CITY OF ALBUQUERQUE

Re: Maverik University & Menaul
1901 Menaul Blvd NE Albuquerque Nm 87107
Traffic Circulation Layout
Engineer's/Architect's Stamp 07-25-2019 (H15D068)

Based upon the information provided in your submittal received 07-25-2019, the above referenced plan cannot be approved for Building Permit until the following comments are addressed:

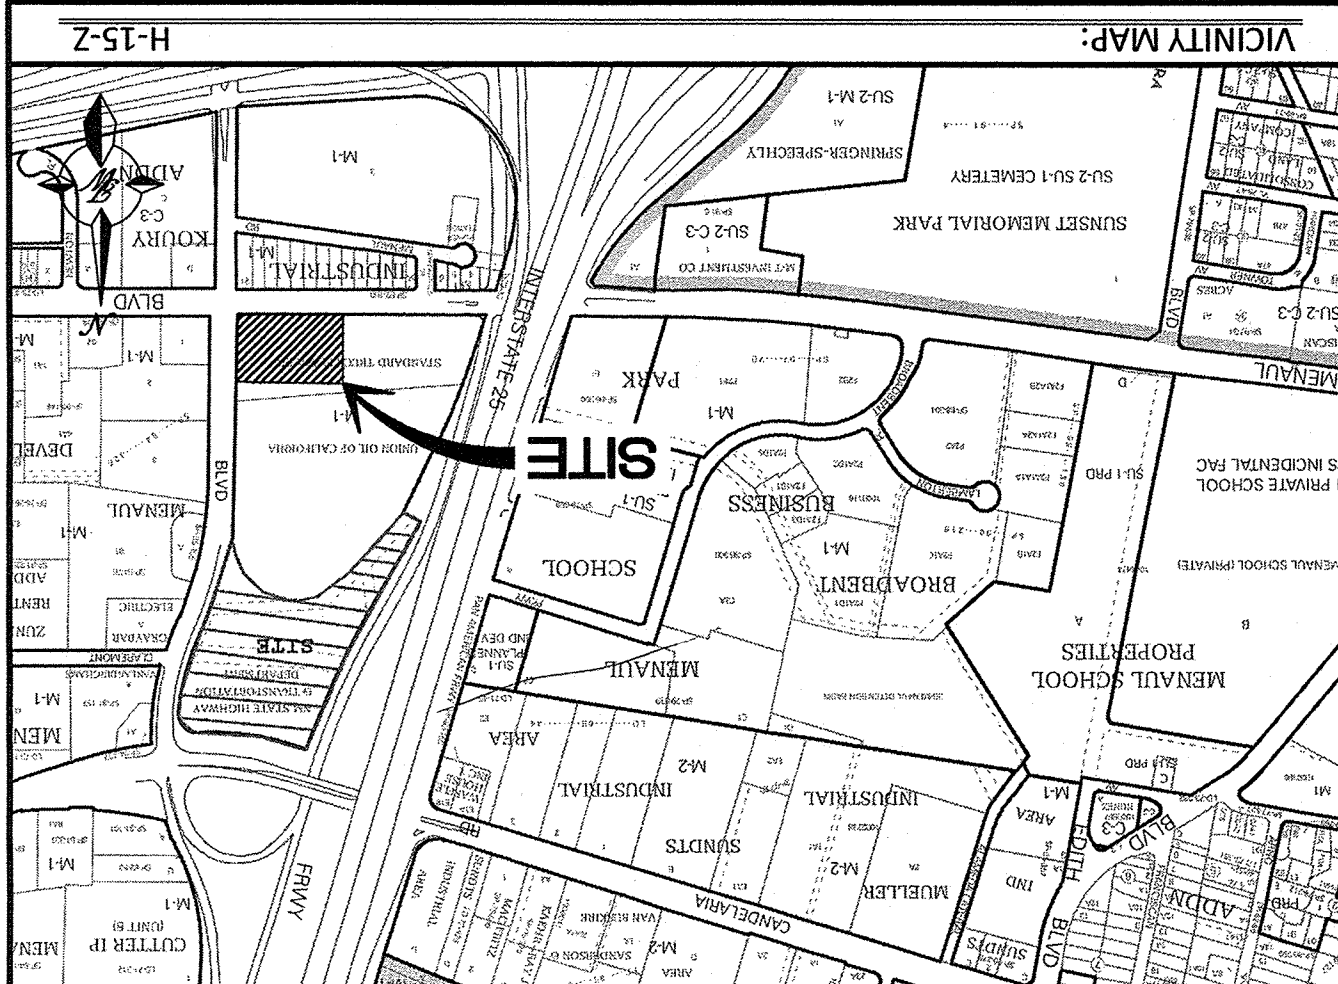
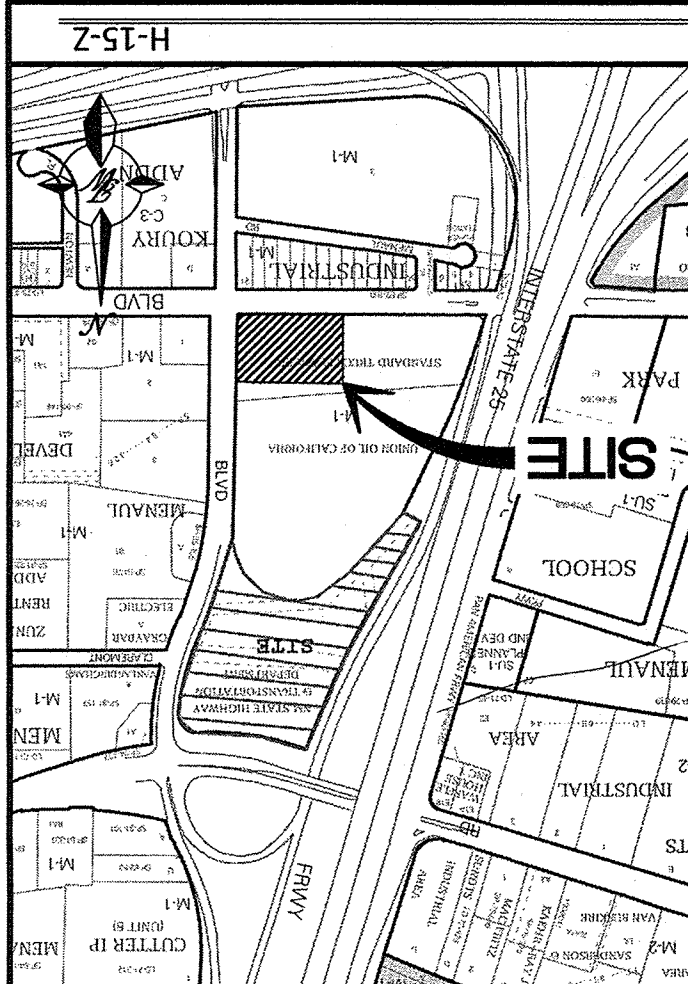
Send bicycle location approval?
